Technical Bulletin

CS Sockets Improved Contact Reliability

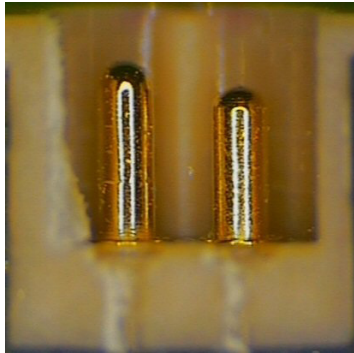
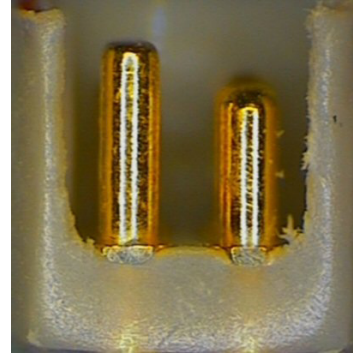
We have improved the contact reliability between the Socket and the CS Plug, extending the ground pin length by 0.1mm.

Consequently, this change will have no influence on the part numbers that you order today. The improvement was implemented in February 2009. It is possible to identify improved parts by the visual appearance inside the Socket – improved ground pin has a more flat edge on the top than the previously.
